Exhibit 1: Lack of Required Signage

Exhibit 2: Lack of Handicapped-Accessible Entrances to Park

Exhibit 4: Lack of Required Parking Signage

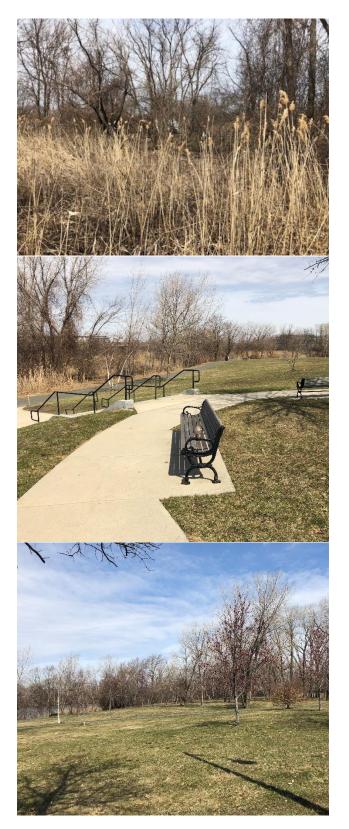
The single sign indicating the designated parking area for park users is located at the farthest end of the parking area from the entrance to the designated parking area, so most potential park patrons probably do not even see it. The designated parking area consists of 39 spaces (supposed to be 40), so one sign is not sufficient to inform potential park users about where to park.
